**In the Drawings:**

A proposed change to Figure 11 of the drawings is attached.

## REMARKS

FIG. 11

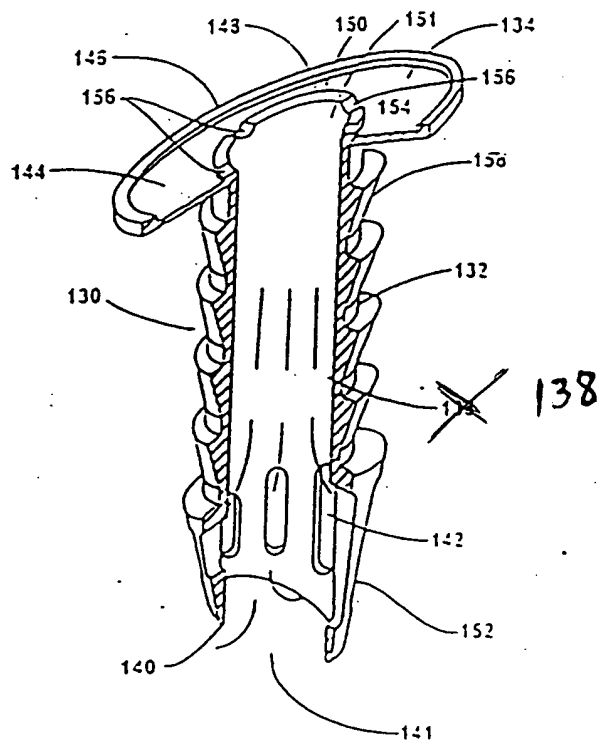
The Applicants respectfully request the Examiner's approval of the proposed change to Figure 11 of the drawings attached as Appendix A. In the drawings previously submitted, due to apparent fading during photocopying, reference numeral 138 appeared to look like "133." This is corrected in the attached change. Replacement formal drawings are also being simultaneously herewith.

In paragraph 2 of the Office Action, the Examiner objected to the drawings. The attached drawing change is made in response. In addition, the Applicants respectfully point out that reference numeral 28 is mentioned in the specification in paragraph 35 ("a portion 28 of the conjunctiva 18 which normally covers the intended implantation site").
